**SERVICING DESIGN BRIEF
AND
STORMWATER MANAGEMENT
REPORT**

1420 EARL ARMSTRONG ROAD

**SITE PLAN APPLICATION
FILE No. DO7-12-14-0067**

12007.330
APRIL 9, 2014
REVISED JUNE 20, 2014
REVISED AUGUST 13, 2014

FILE No D07-12-14-0067
GRADING PLAN

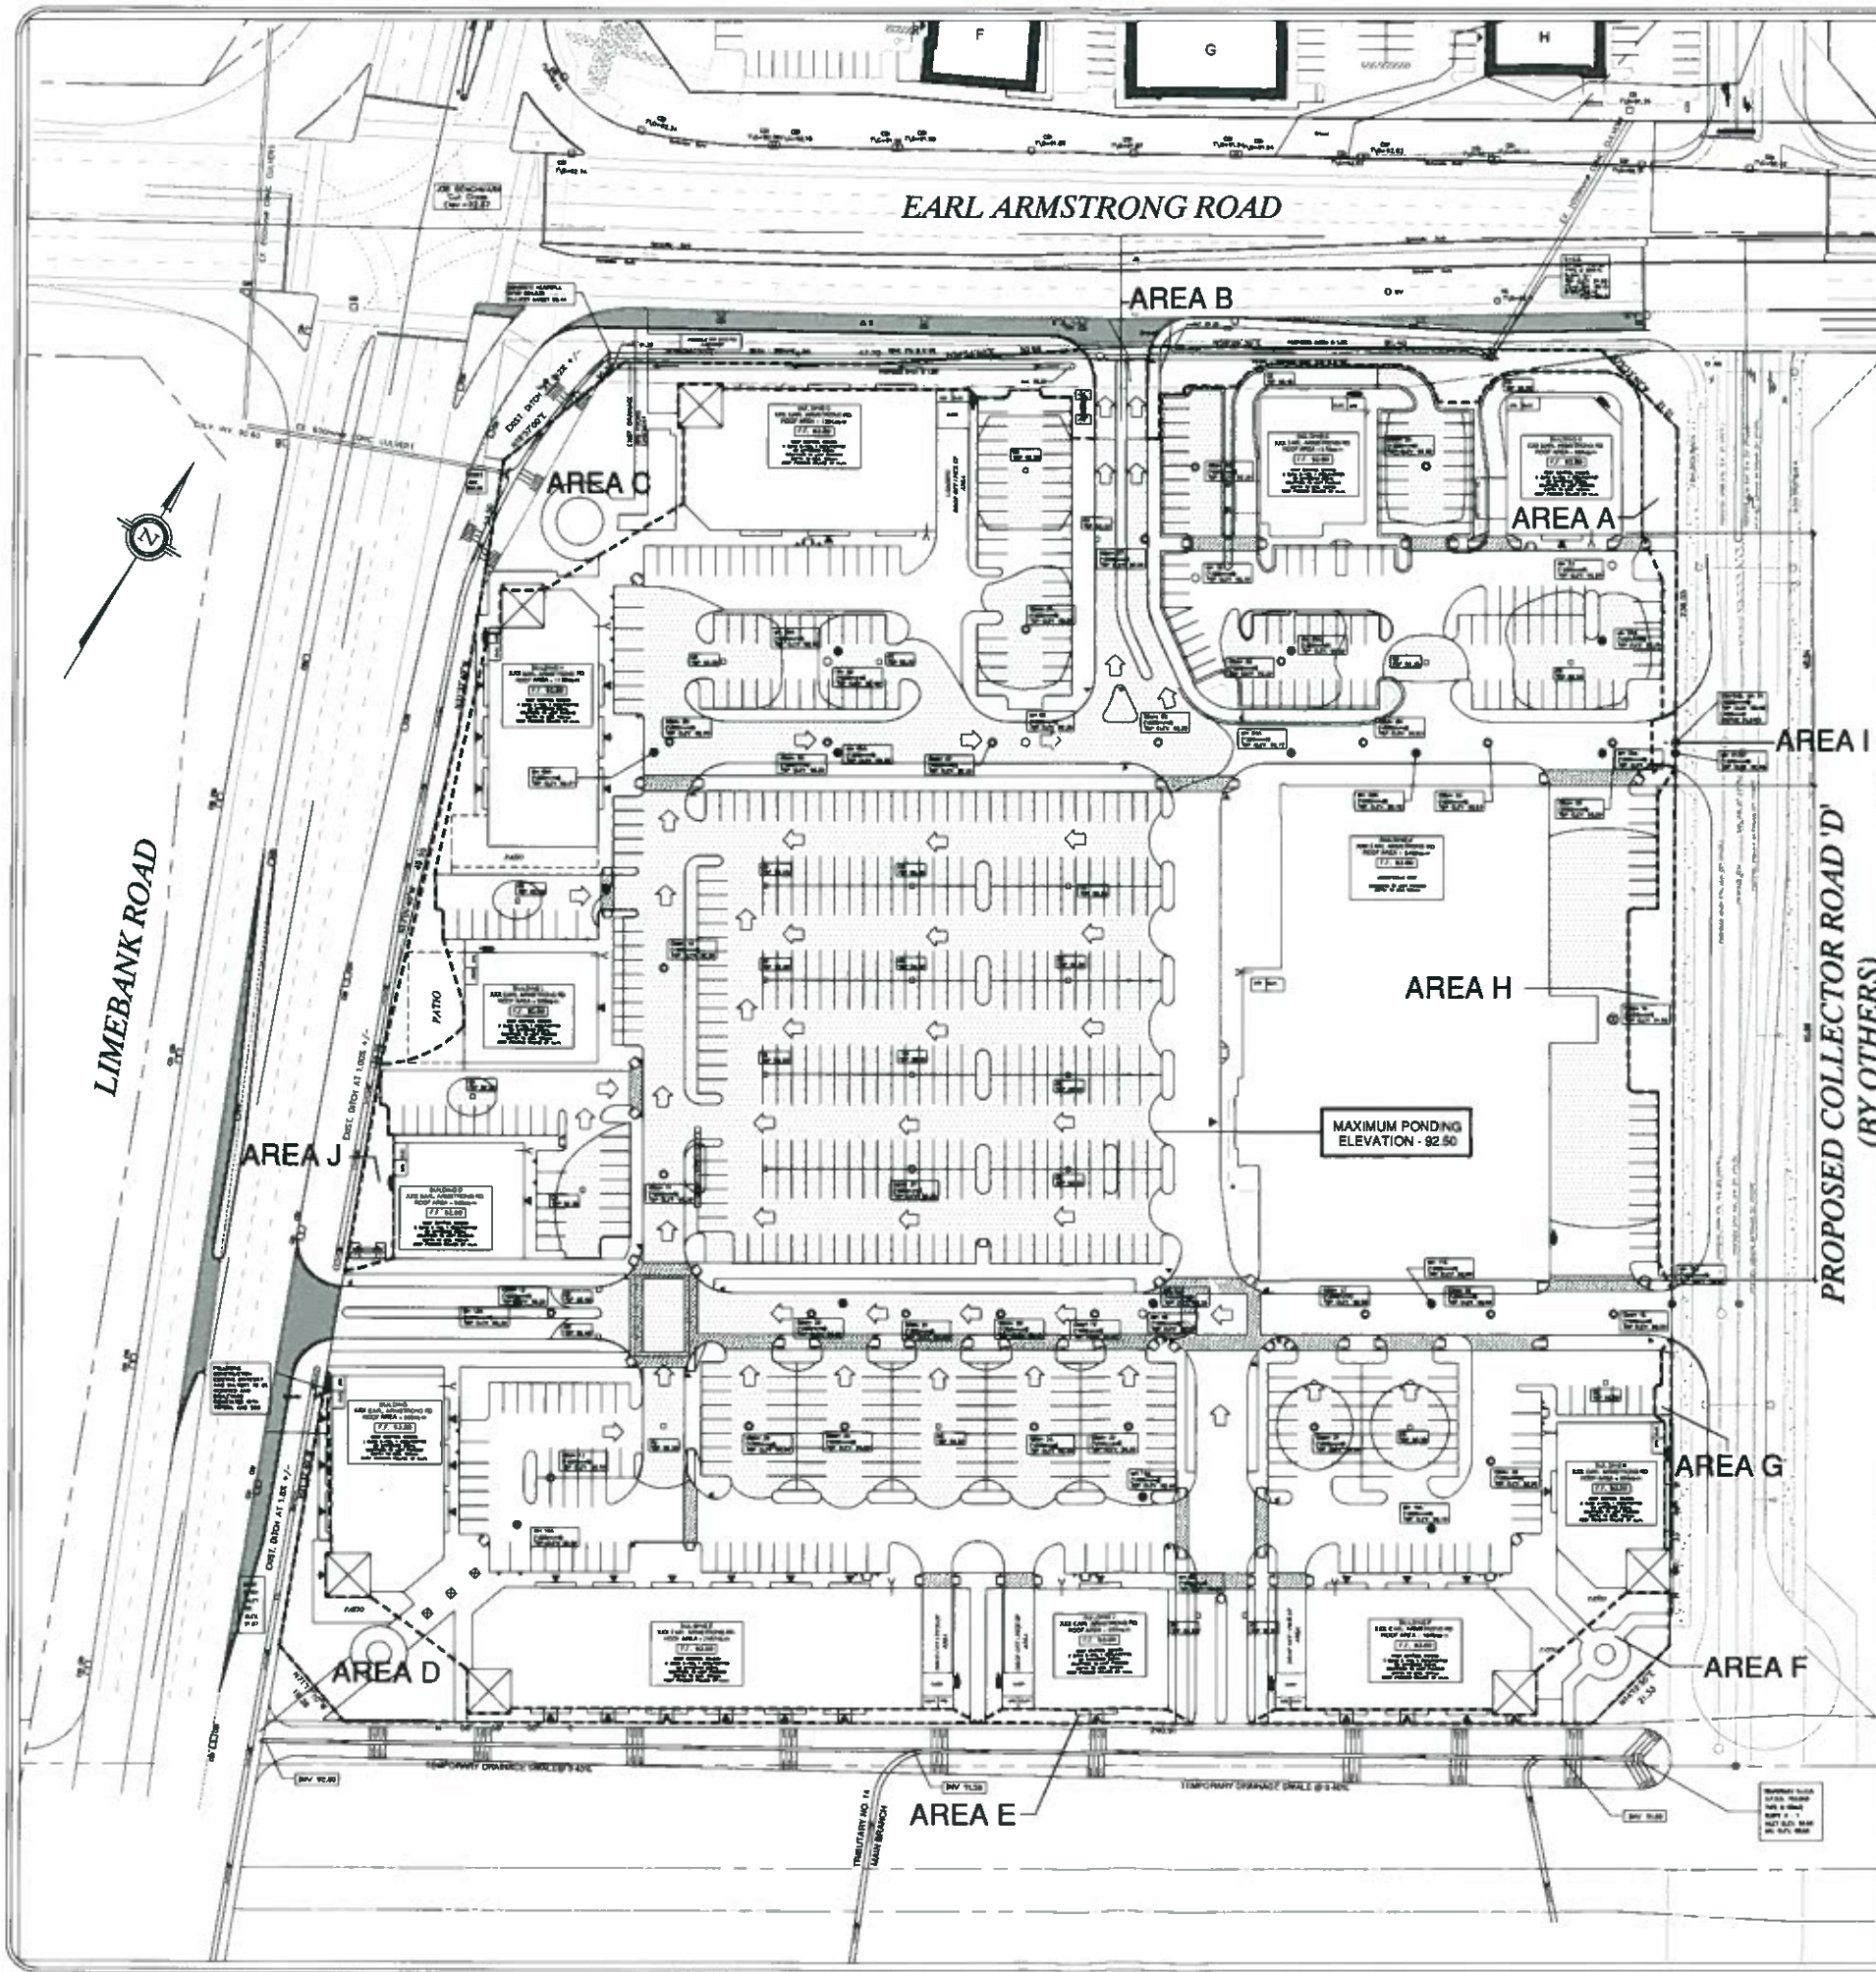
6. Site Servicing Plan – Servicing & Grading Information for Collector 'D' is missing (55 copies)

Response: *The current design information for Collector Road 'D' has been up-dated on the site grading and servicing plans*

FILE No D07-12-14-0067
EXTERNAL STORM DRAINAGE AREA PLAN

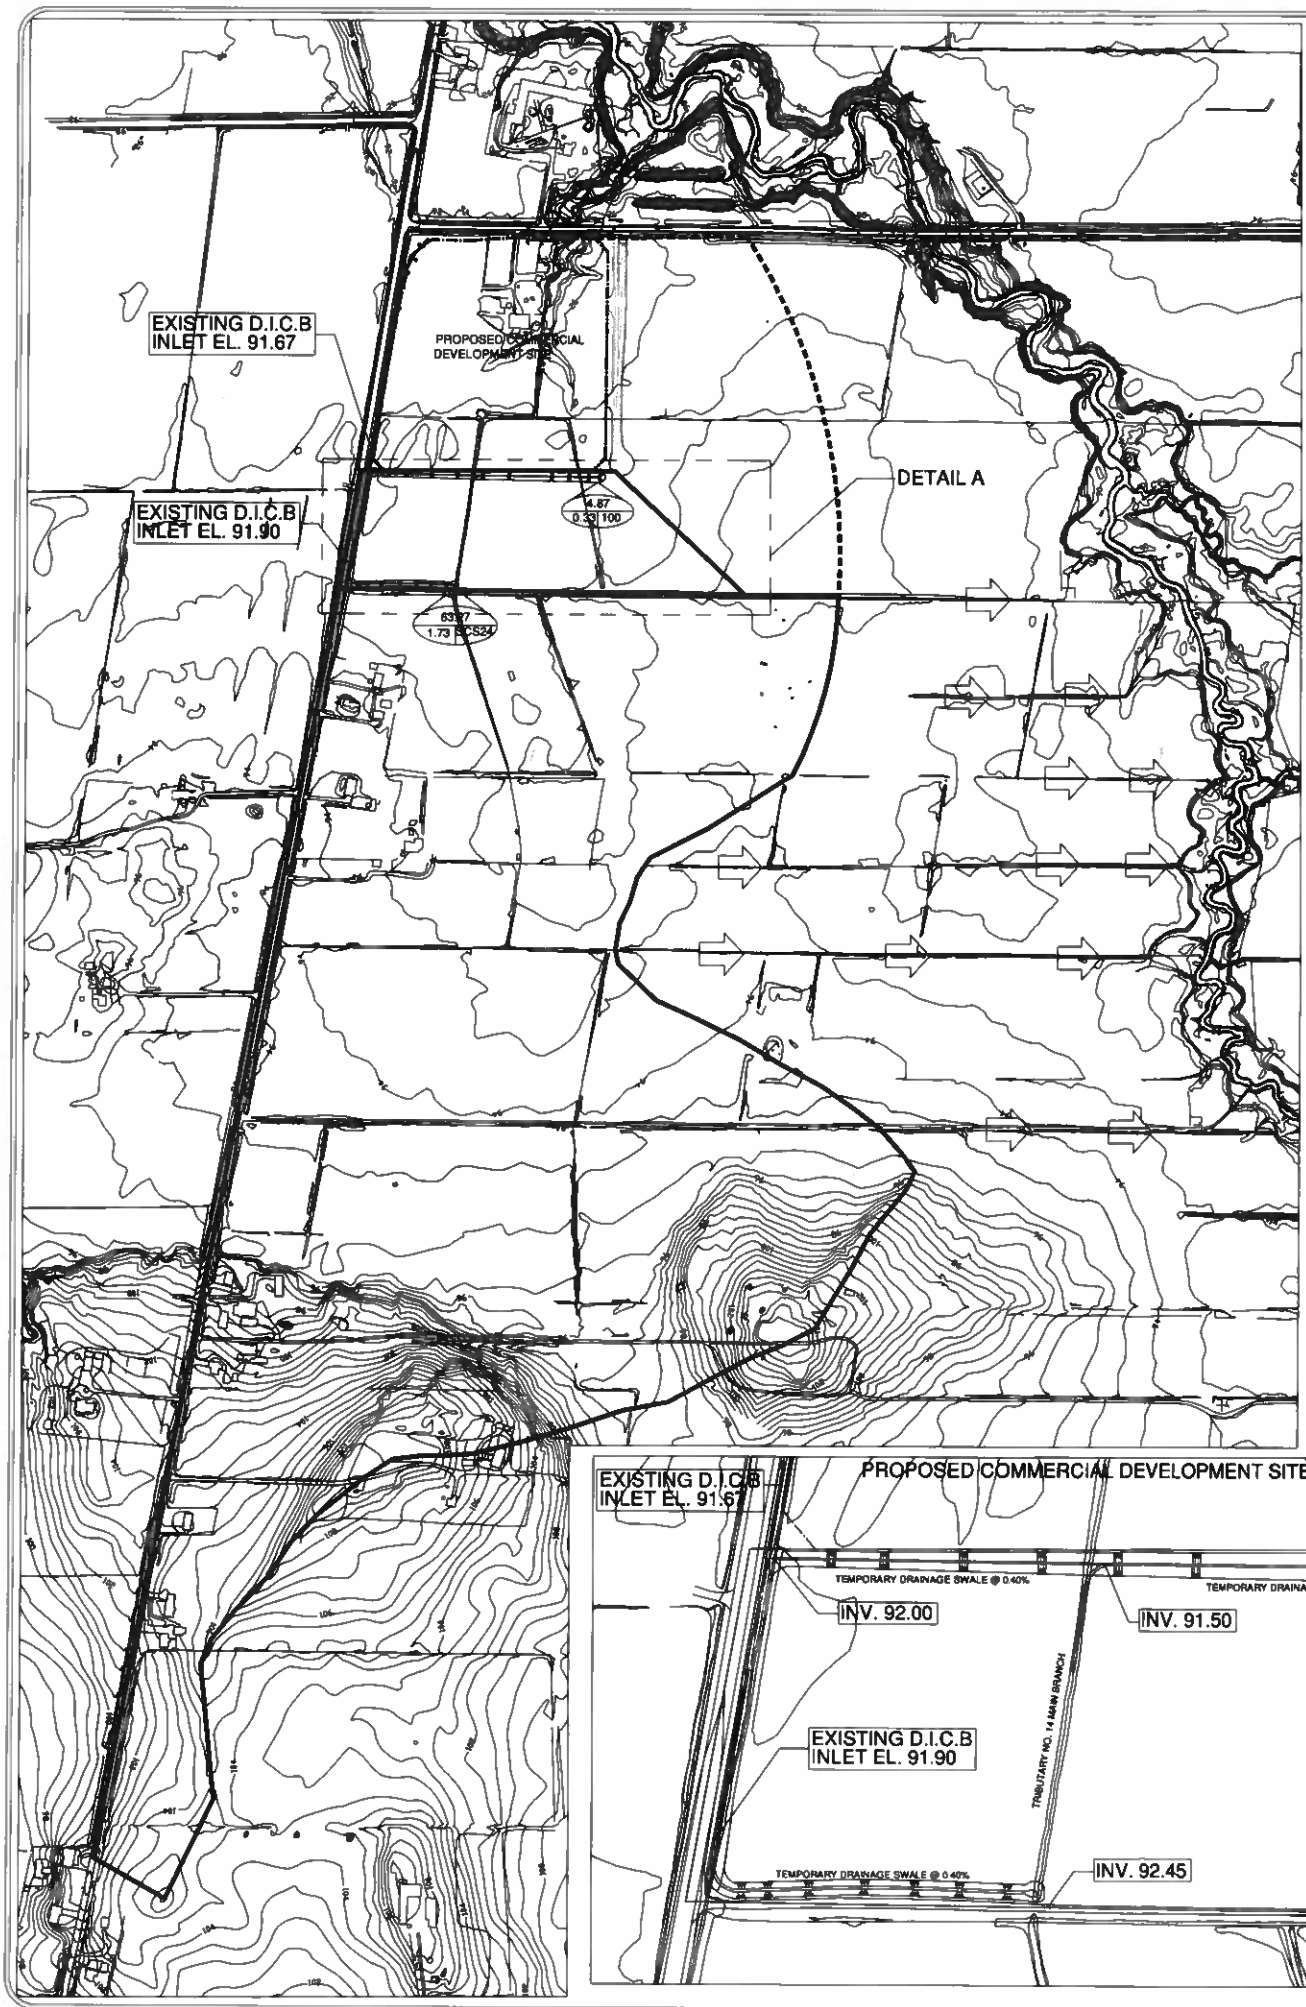
2. Stormwater Management Report – Tributary #14 Drainage Area & Supporting calculations are missing from the Report – need to updated Report (6 Copies)

Response: *Paragraph 3.4 Tributary No. 14 and the Hydraulic Evaluation Report have been revised and Appendix 'C', Tributary No. 14 Calculations have been added*
